Technical Note 01

Kronospan Response to LHA Consultation Response

3046-01-TN01

1.1.1 This Technical Note (TN) has been prepared in connection to the application for the construction and operation of a northern access road and lorry park ('the Proposed Development') north of the existing Kronospan Facility in Chirk, Wrexham (planning application reference P/2022/1080).

Appendix C – Drawing No. 3046-01-D01A: Proposed Roundabout Layout and Visibility Splays

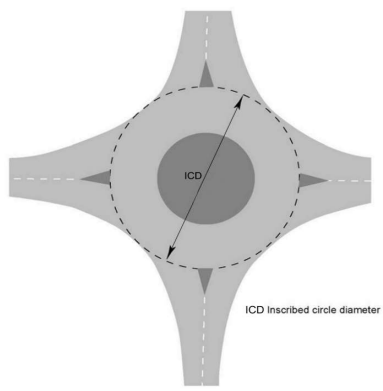
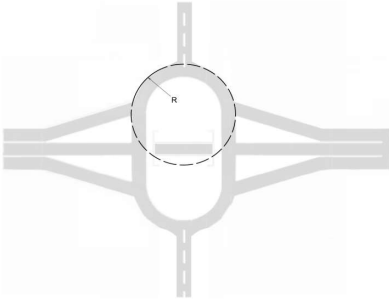
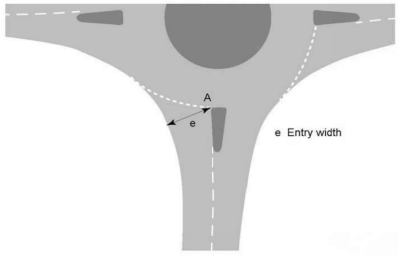
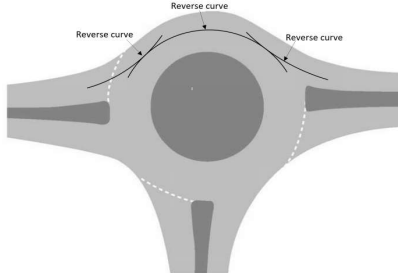
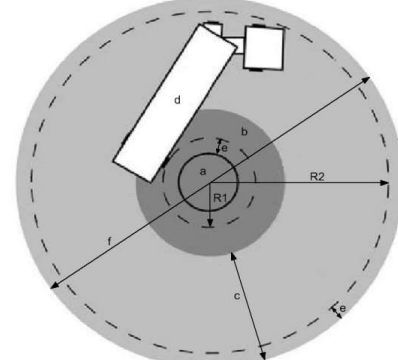
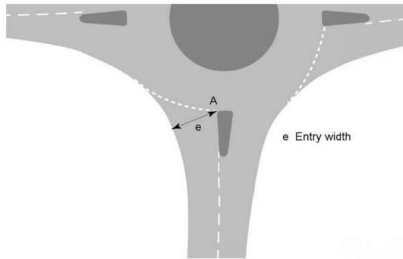
LHA Comment – “The applicant has provided visibility splays of 2.4m x 120m appropriate for a 40mph speed limit. Revised visibility splays should be provided in line with TAN18 for 50mph.”

The applicant has provided visibility splays of 2.4m x 120m appropriate for a 40mph speed limit. Revised visibility splays should be provided in line with TAN18 for 50mph.

- 2.3.1 Contrary to the comments provided in the LHA response, it is considered that the visibility splays for the proposed roundabout included on **Drawing No' 3046-01-D01** contained within **Appendix C** are appropriate for the anticipated design speed of the road, following the reduction of the posted speed limit to 40mph.

**Appendix E – Drawing No. 3046-01-
ATR01A: Proposed Roundabout Swept
Path Analysis**

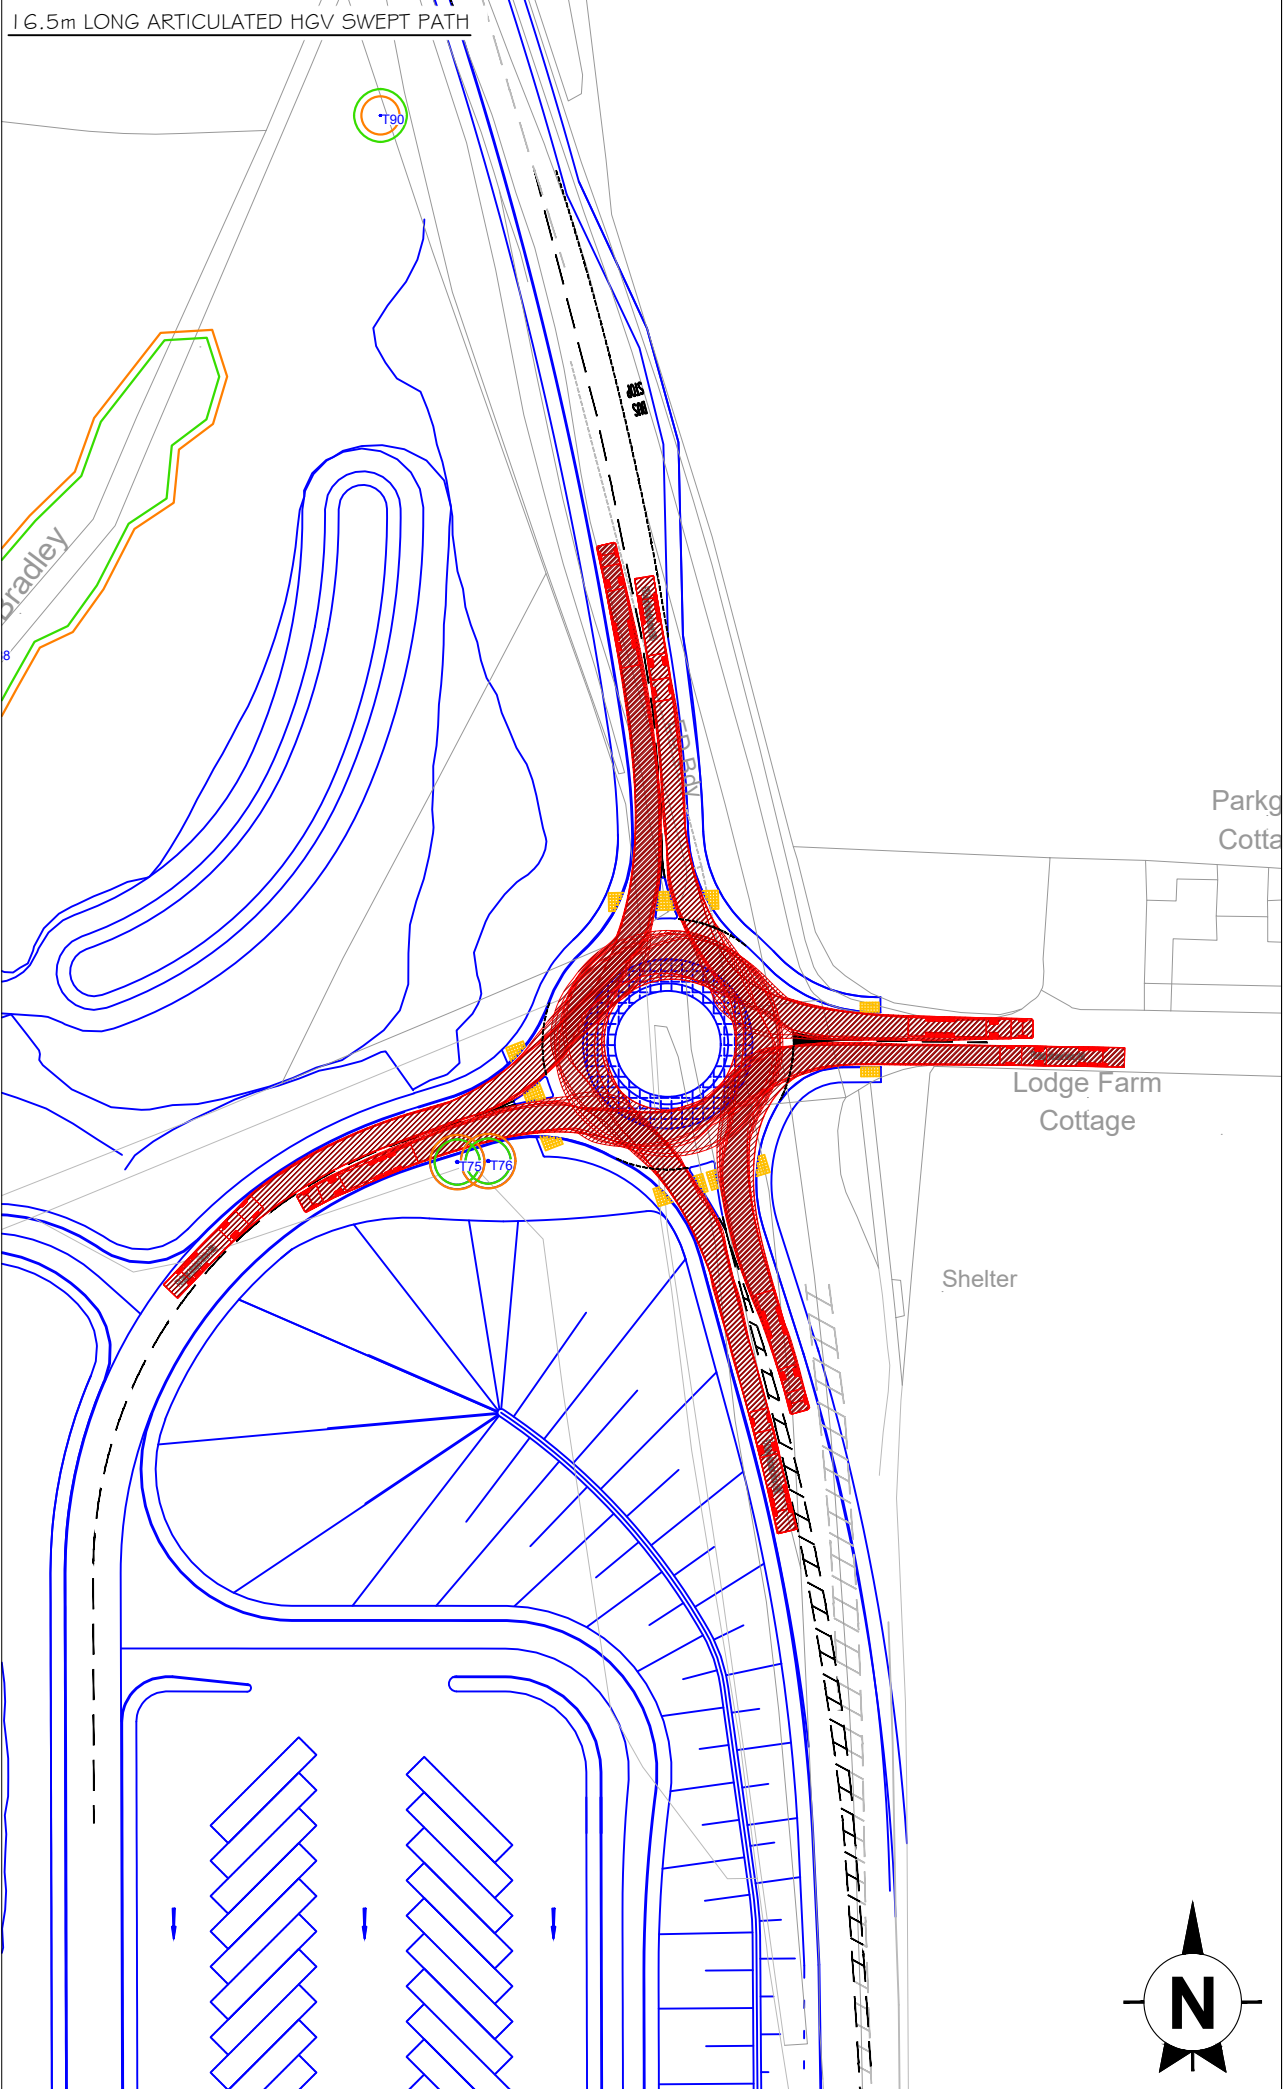
LHA Comment - “The proposed roundabout layouts provided by the applicant (Ref. 3046-01-D01 & 3046-01-ATR01) indicate a compact roundabout design. A standard roundabout should be provided to accommodate the level of HGV movements to and from the site. This should comprise two circulatory lanes and a flared two-lane entry at the B5070 north arm. The right entry lane should be of sufficient length to accommodate a right turning HGV with the left lane for general traffic”

LHA Comment – “Vehicle tracking will need to be submitted to demonstrate HGV parking and turning provision within the site along with vehicle access and egress via the North Access Road.”

The proposed roundabout layouts provided by the applicant (Ref. 3046-01-D01 & 3046-01-ATR01) indicate a compact roundabout design. A standard roundabout should be provided to accommodate the level of HGV movements to and from the site. This should comprise two circulatory lanes and a flared two-lane entry at the B5070 north arm. The right entry lane should be of sufficient length to accommodate a right turning HGV with the left lane for general traffic.

Updated swept path drawings will need to be provided for any revised roundabout design to demonstrate all vehicle movements can be accommodated.

- 2.4.6 If it is inferred from the response that the LHA is concerned that a multiple lane entry / exit arm would be required in order to accommodate the manoeuvres of HGVs to and from the site, again this is unfounded. The swept path analysis provided in the TA (**Drawing No: 3046-01-ATR01** contained within **Appendix E** at the end of this report) demonstrates that a single lane entry / exit would be sufficient to accommodate the manoeuvres of a 16.5m long articulated HGV. This is consistent with paragraph 3.14.3 of DMRB CD116 which states that “*Vehicle swept paths should be assessed using the largest design vehicle that is anticipated to use each entry lane*”. The LHA’s response infers that compact roundabouts are not able to accommodate the swept paths / manoeuvres of large HGVs. Given sufficient entry / exit kerb radius, circulatory carriageway width and various other factors as set out in CD116 for compact roundabouts, this is demonstrably not the case.

- 2.6.1 Swept path analysis of the proposed northern access road and roundabout are included in **Drawing No. 3046-01-ATR01A** in **Appendix E**.
- 2.6.2 The swept path of the (revised) HGV parking area will be provided in the TA addendum.
